CAPELLA HOUSE CAR PARK

DESIGN & ACCESS STATEMENT ADDENDUM

3.00 Revisions To Plans

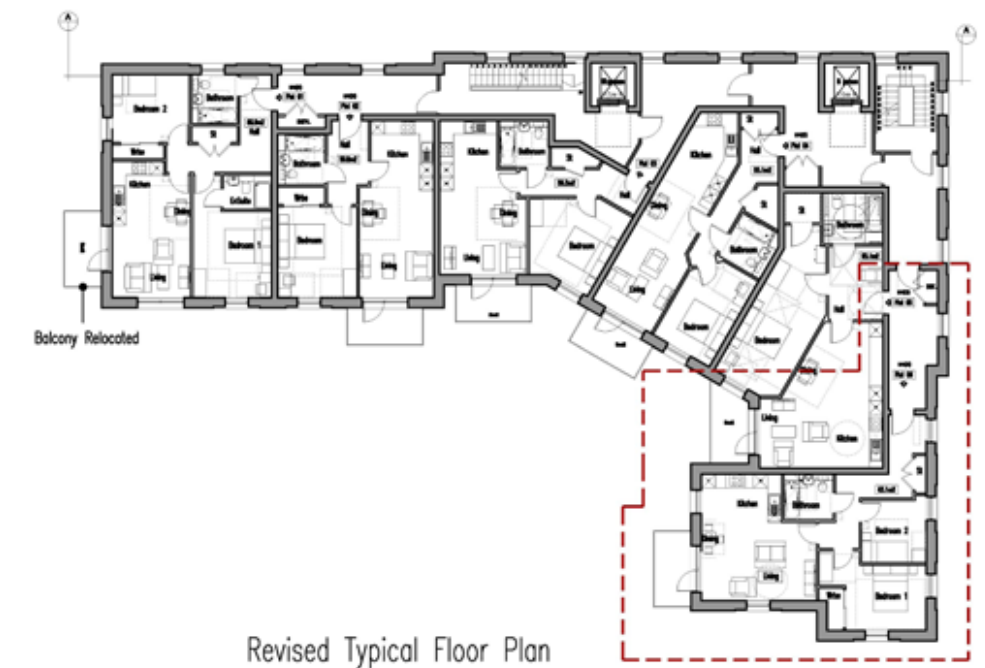
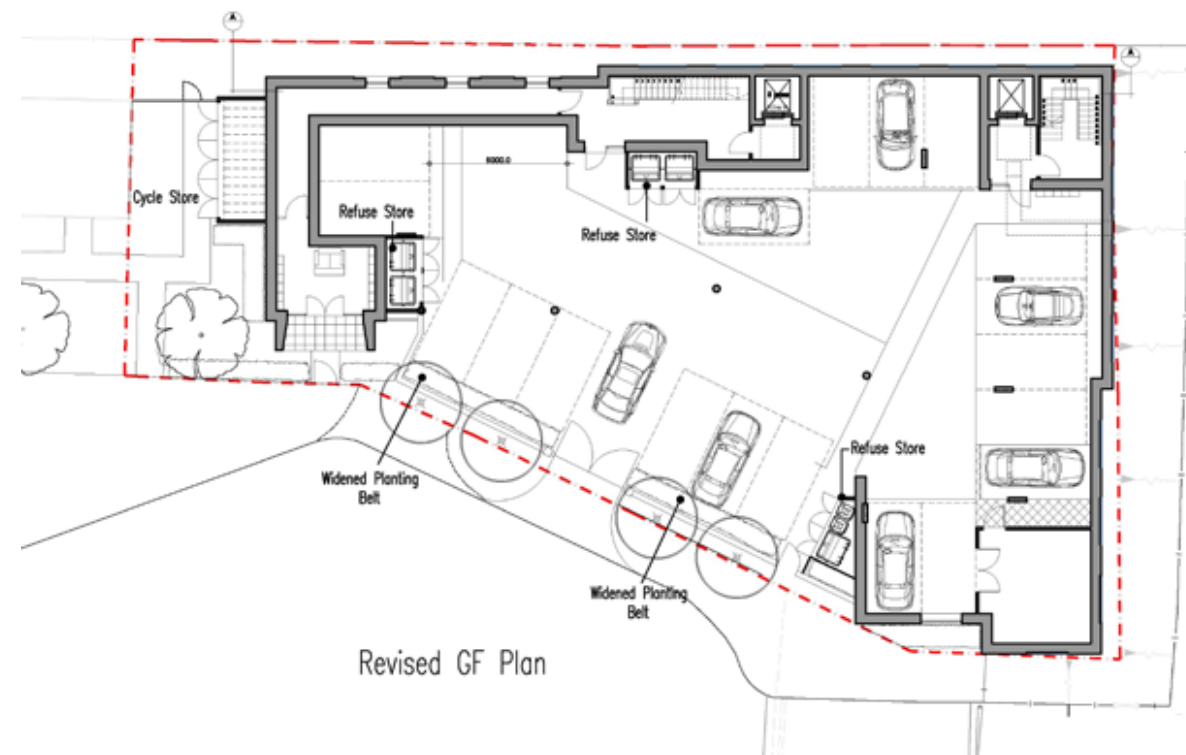
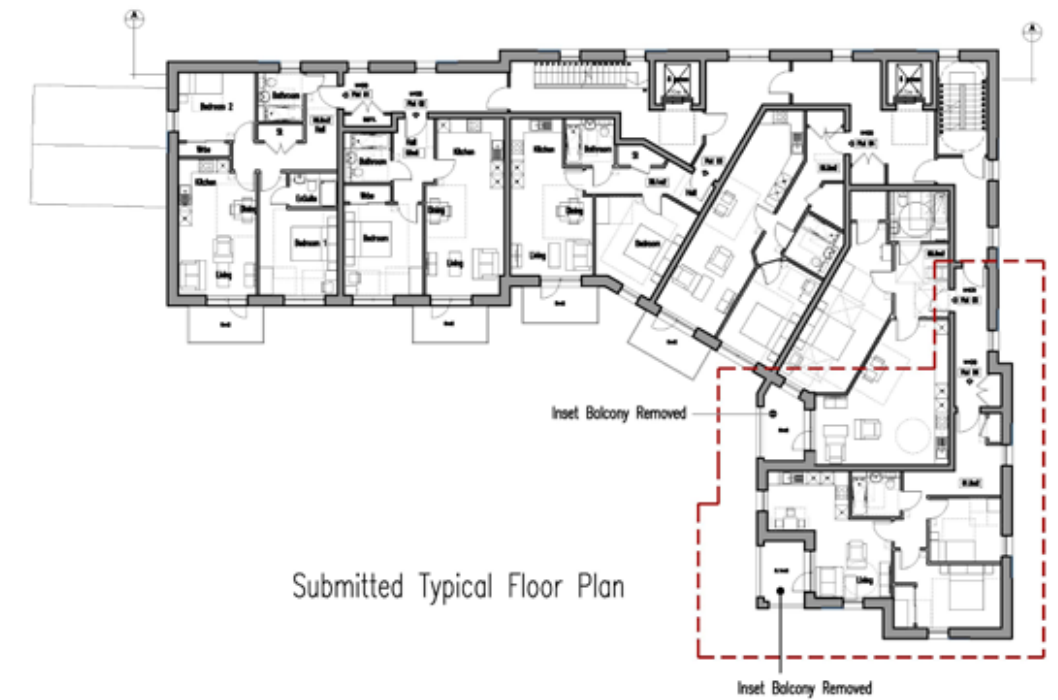
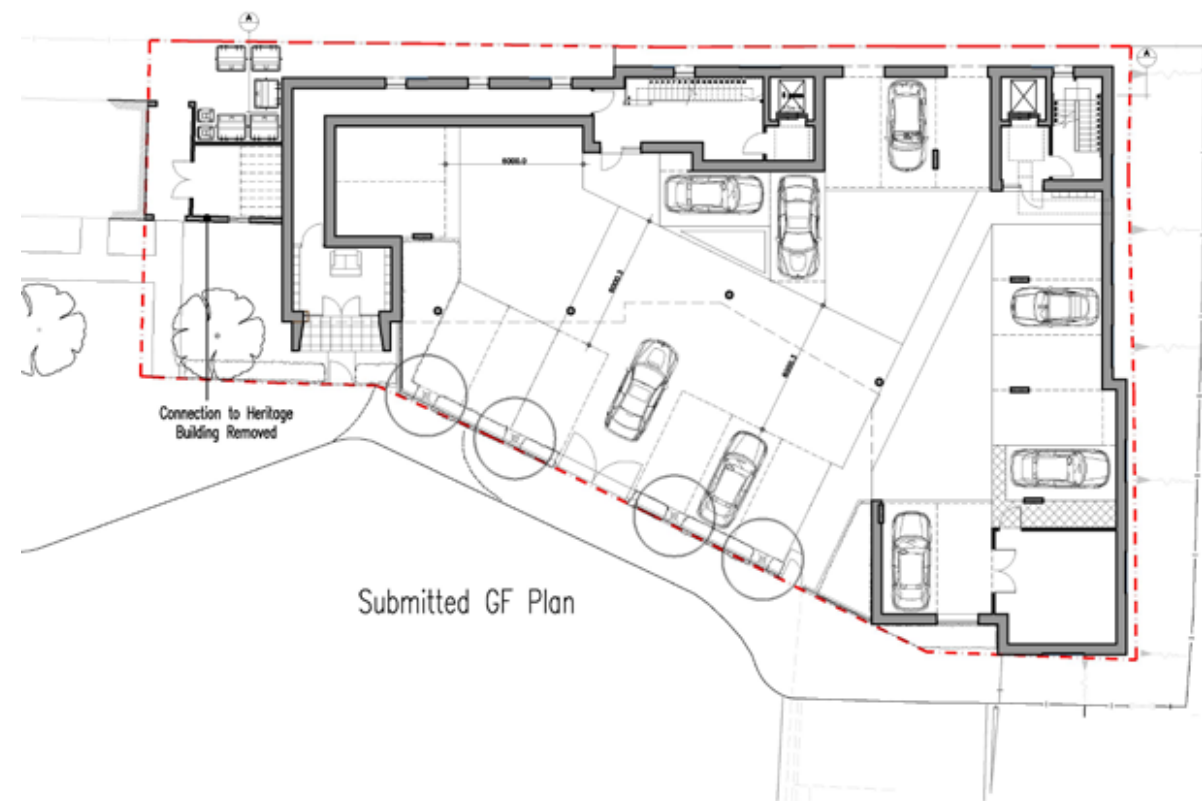
The LPA expressed concerns regarding the provision of natural daylight to the flats located in the south-east corner of the building.

The submitted design incorporated inset balconies in these locations. To improve the penetration of natural daylight into the affected flats, the inset balconies were replaced with projecting balconies.

The upper western floors were also redesigned to create a staggered two-storey penthouse element, reducing the overall number of flats from 29 to 28.

This enabled the western element to step down and, in combination with the removal of the attached link, reduced the level of harm to the Listed Building.

Submitted Street Elevation Along Railway Approach

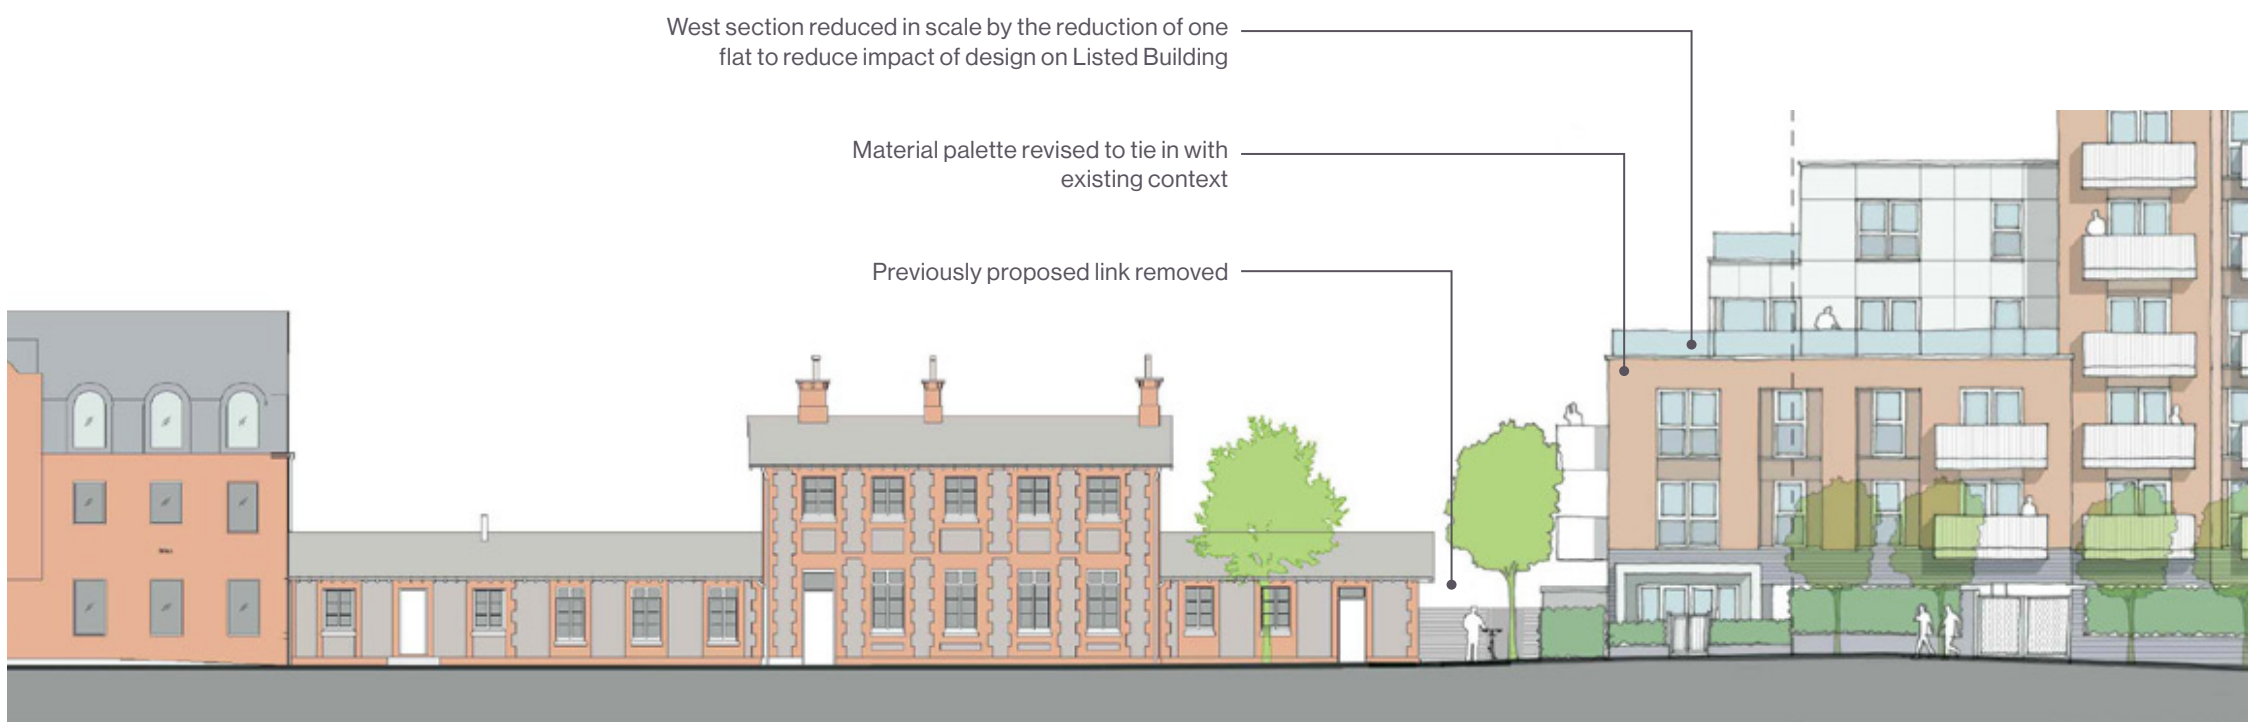
The original elevations were designed with a palette of materials intended to contrast with the predominance of red brick within the surrounding area. The detailing included rusticated brickwork, horizontal banding, a rusticated grey/blue brick plinth, and localised inset balconies. The LPA considered the proposed north and east elevations to be overly simplistic and requested a greater level of articulation.

Sketch street view of proposed landscaping amendments

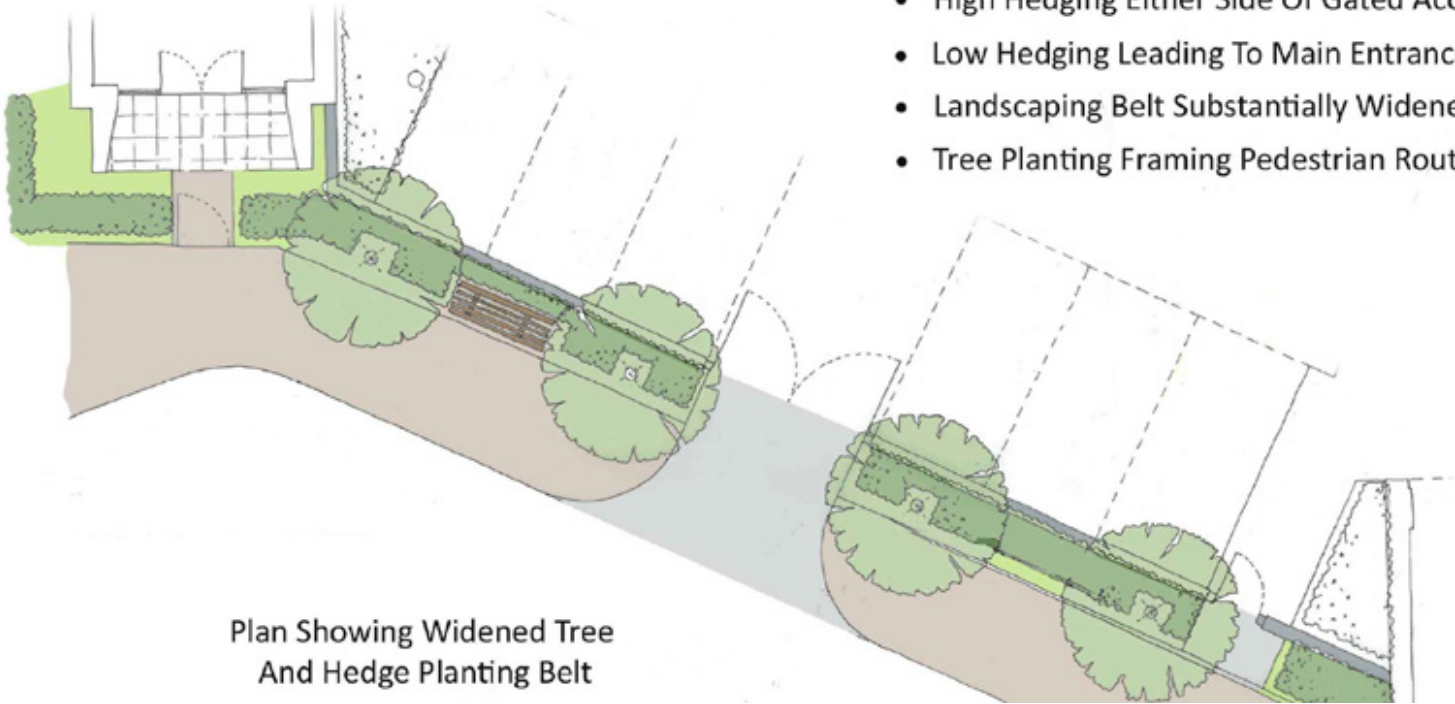
The LPA were concerned with the lack of an activated frontage along the southern edge. They were of the opinion that the retention of car parking retained for the use of offices was compromising the design in regard to quality of the public realm.

The design team explained that retention of car parking was a leasehold requirement and produced the above illustration to demonstrate how an attractive design fronting the public realm could still be achieved through considered landscape design.

The revised approach involved repositioning the proposed boundary wall to the edge of the parking bays and bringing forward planting beds to soften the streetscape, enhance the landscape setting, and provide a more attractive frontage to the public realm.

Plan Showing Widened Tree And Hedge Planting Belt

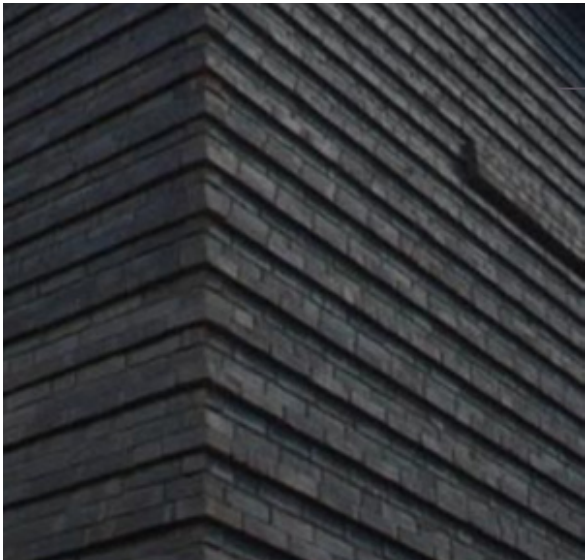
- They would like to see deeper landscaping along the main and secondary entrances to activate help the frontage.
- It was noted that the size of the tree pits may not be sufficient to allow the size of trees shown on the plans to establish and this would need to be clarified.
- There were concerns about the rear of the building given its prominence in views from Broadwater Road. The proposed set backs were noted, although the LPA wished to see further articulation of these elevations.

Following the latest round of comments, the tree grilles have been increased in size to 1.5m x 1.5m to align with the new tree planting introduced along Railway Approach.

Whilst the 1.5m x 1.5m zone provides sufficient space for tree installation, the root system will benefit from access to the full width of the planting bed.

This will be developed further as part of the detailed condition stage. Should additional root volume be required, there is potential to increase the available growing medium through the use of structural soil beneath the parking bays.

Third Floor Plan

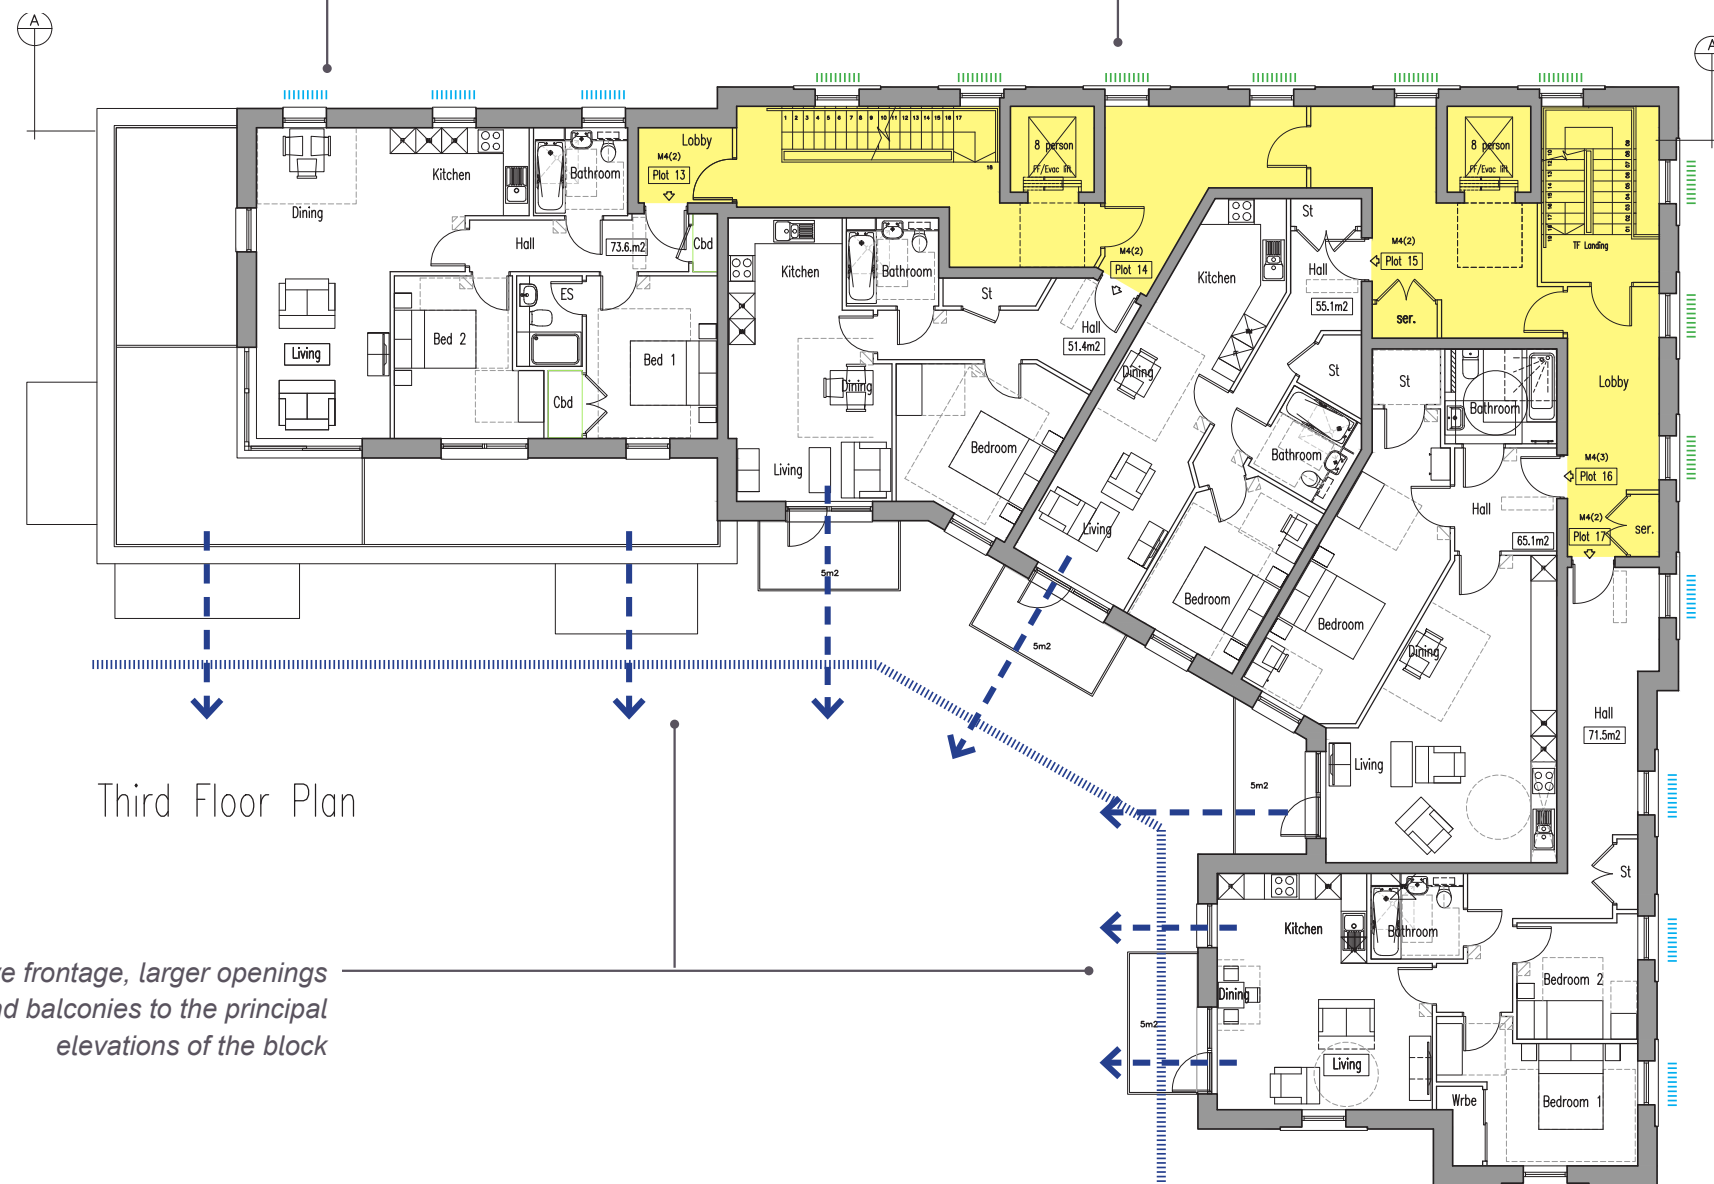
'There were concerns about the rear of the building given its prominence in views from Broadwater Road.'

The proposed set backs were noted, although the LPA wished to see further articulation of these elevations.'

The design team consider the eastern and northern elevations in the scheme to be appropriate and well considered responses to the to surrounding context of the site. We provide the following justification of the proposed design in response to this comment.

As part of this response the proposed layout has positioned the circulation routes, stairs, lifts and ancillary accommodation towards these boundaries to act as a buffer to the apartments themselves.

As a result, the fenestration to the north and east elevations predominantly serves the circulation areas. Owing to the proximity of these elevations to the site boundaries, the size and extent of openings are restricted by the Building Regulations in relation to unprotected areas.

The design team considers that the introduction of additional architectural detailing to these elevations without a clear functional or contextual purpose would weaken the overall architectural language of the building.
